RADIOLOGICAL EFFLUENT TECHNICAL SPECIFICATIONS  
(RETS) IMPLEMENTATION - KEWAUNEE NUCLEAR POWER  
PLANT

*FINAL*  
~~Informal Report~~  
*JULY 22, 1985*

EGG-PBS-6883

Figure 1 Kewaunee Liquid Radwaste Treatment and Discharge Pathways

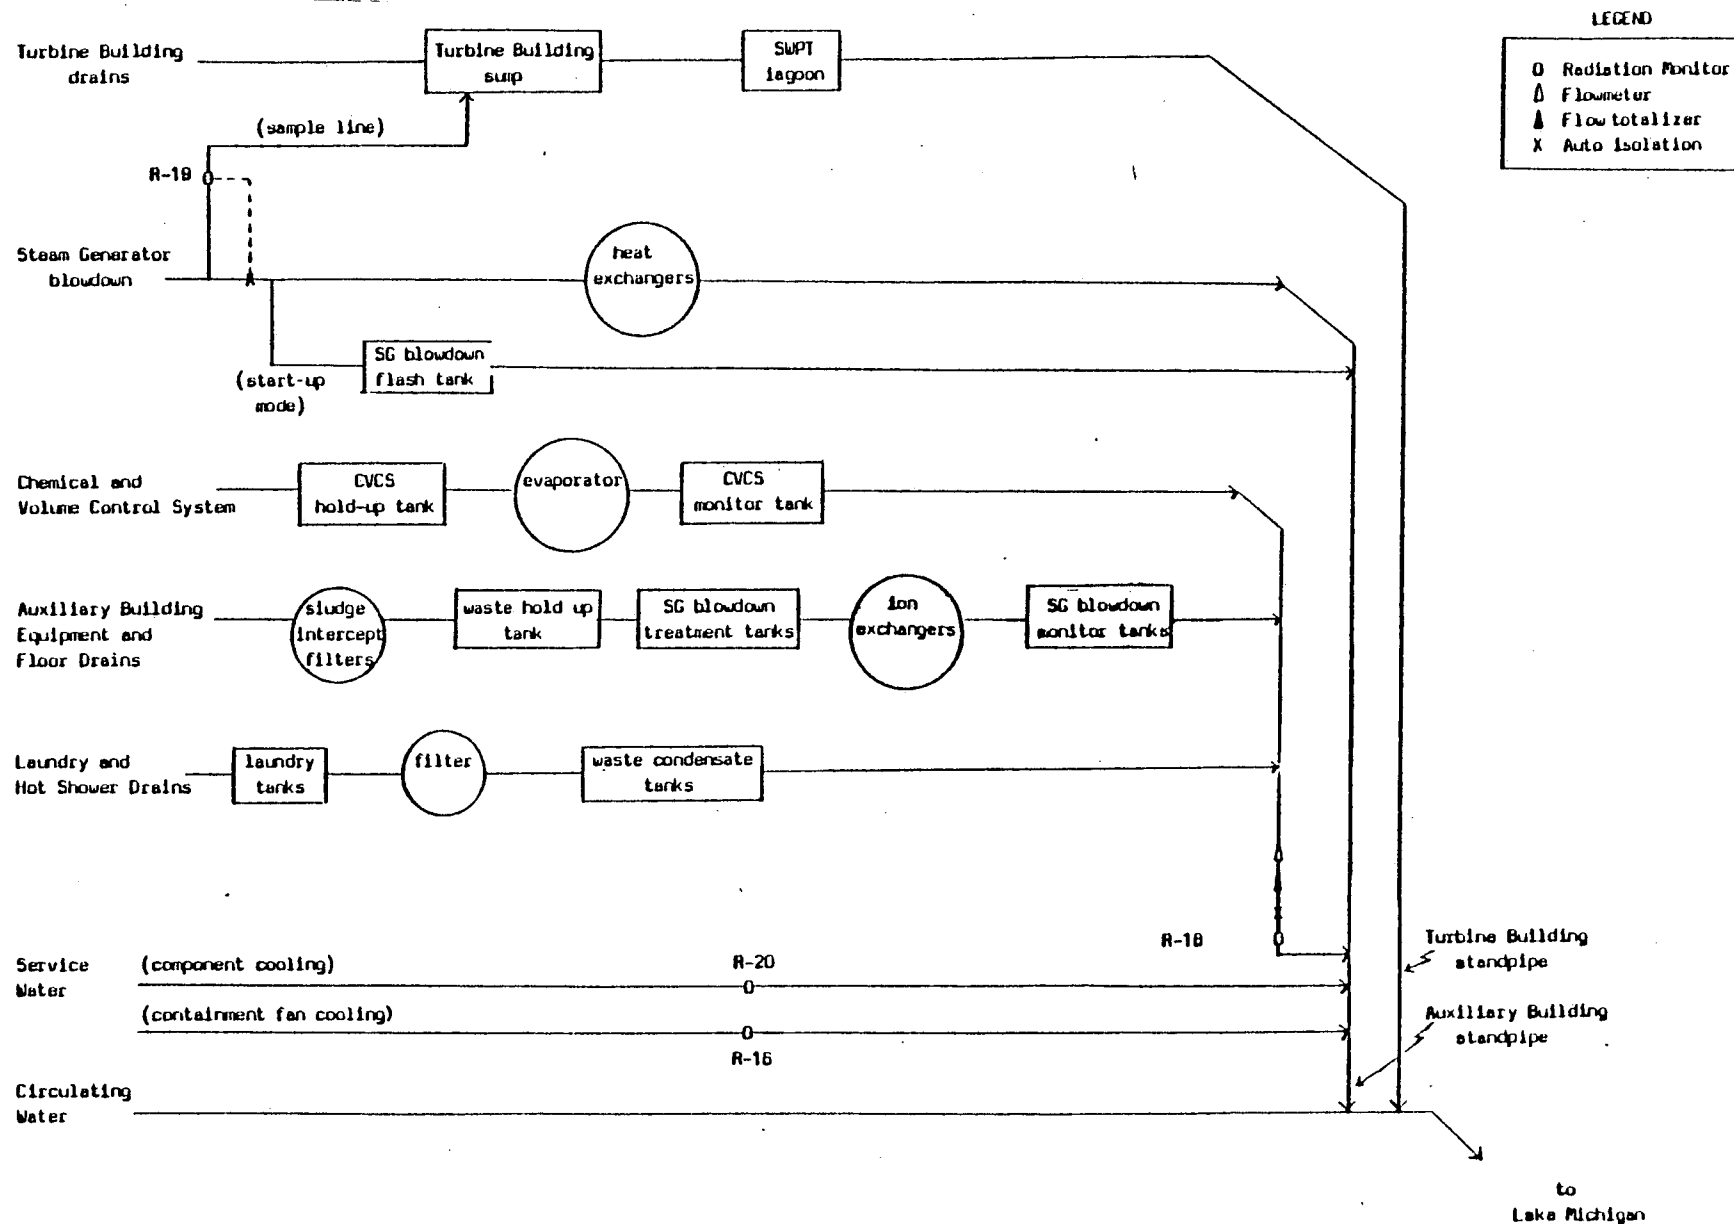
All potentially contaminated radioactive liquid effluents are released to Lake Michigan through the circulating water discharge. The radioactive liquid treatment system and discharge pathways are block diagrammed in Figure 1. The diagram was obtained from the ODCM. The block diagram shows the turbine building sump continuous release and the steam generator blowdown continuous release. The chemical volume control system (CVCS) monitor tank, the steam generator blowdown monitor tanks and the waste condensate tanks are batch released to the auxiliary building standpipe before release via the circulating water discharge.

The monitoring and controls for normal releases of radioactive liquids are indicated in Figure 1. The R-18 monitor provides alarm and automatic termination of release for the liquid radwaste line while the R-19 monitor provides alarm and automatic termination of release for the steam generator blowdown. The R-16 and R-20 monitors provide alarm for the service water discharges.
